THE BABCOCK & WILCOX COMPANY  
POWER GENERATION GROUP

THE-79-179

Action Item 143

B&W's View of Increasing  
Incore Thermocouple Readings (Instruction 143)

Location 12P  
Location 13F  
Location 11L

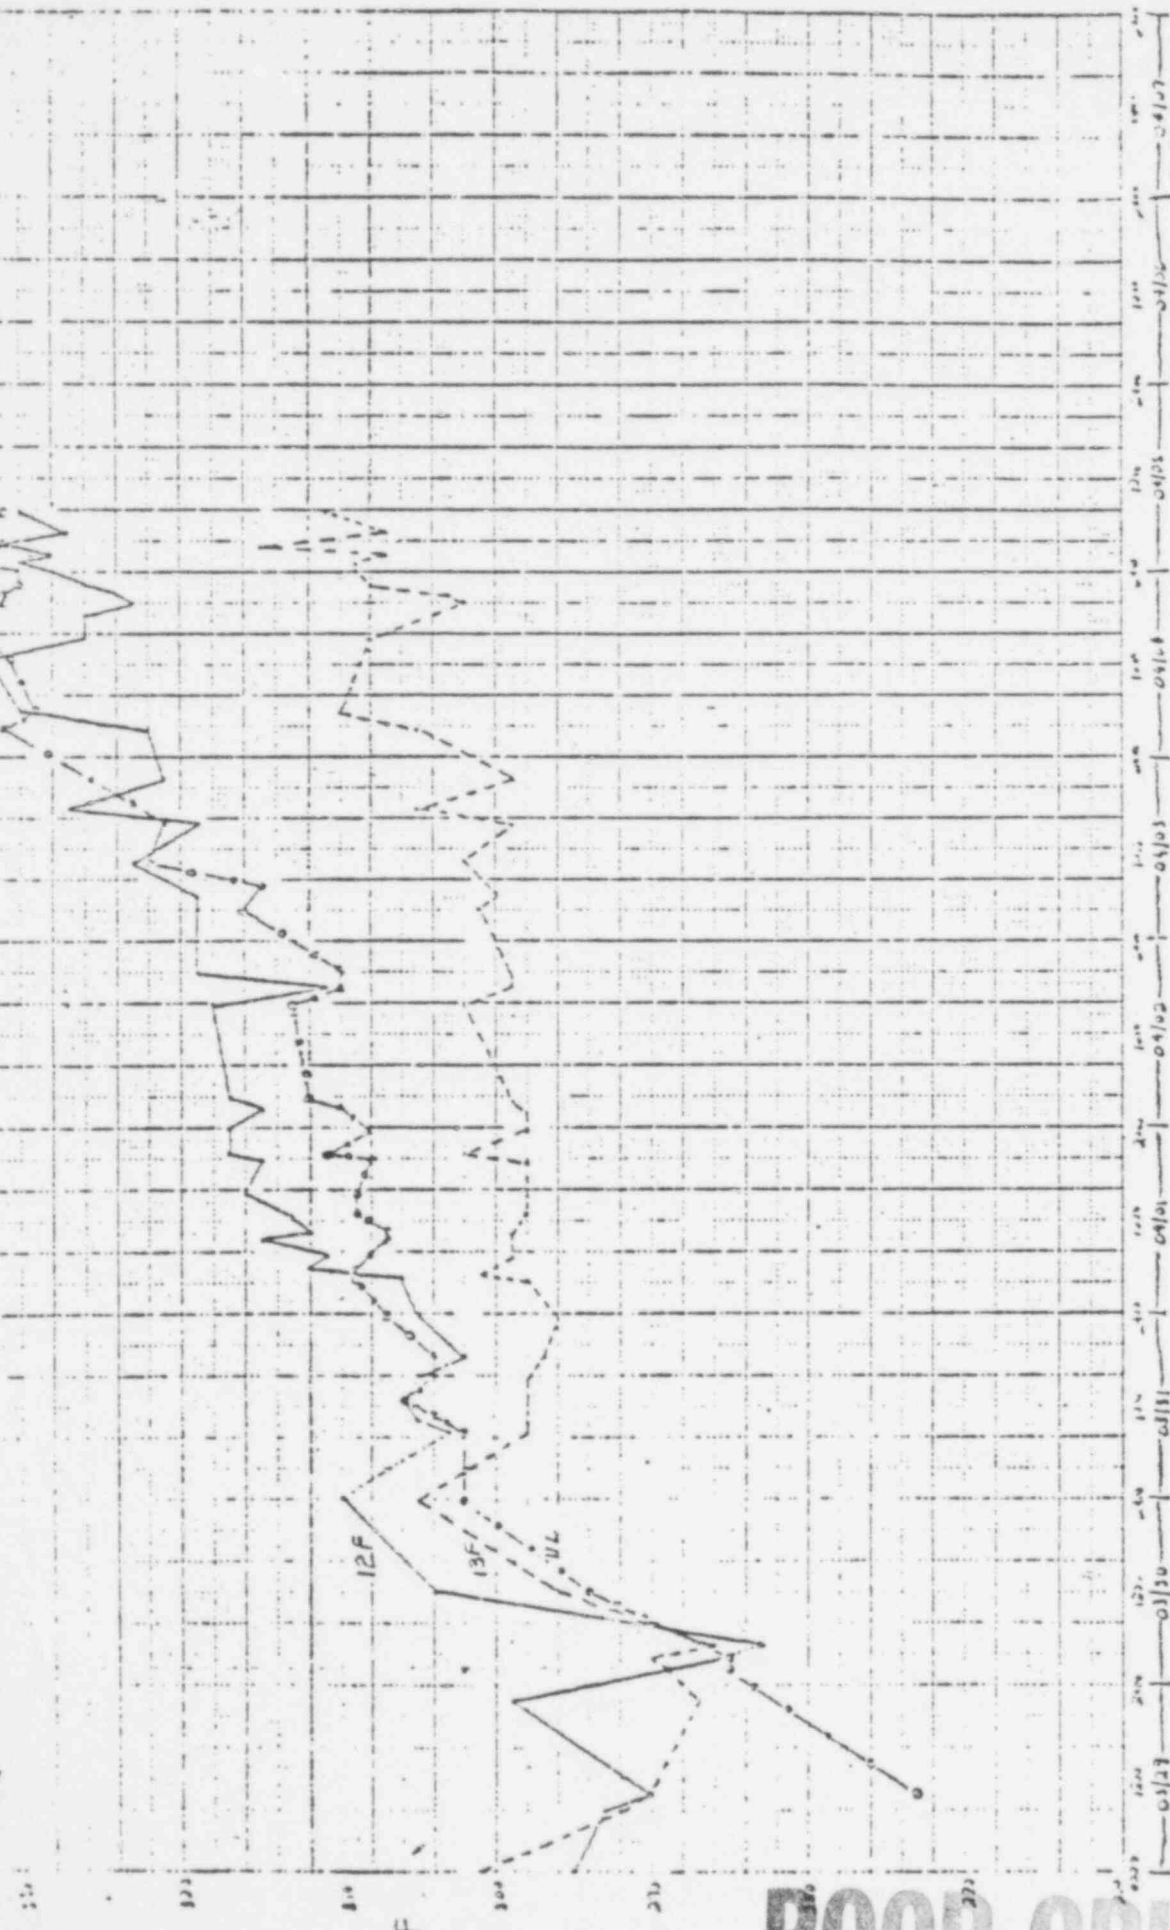
Incore thermocouple data from TMI-2 have been evaluated. As shown below, six of the thirty thermocouples for which we have data have shown a temperature rise of 7 - 33°F over the past 5 days (117 hours) or 1.4 - 6.8°F per day.

Temperature vs time for locations 13F, 12F, and 11L are shown in the attached figure.
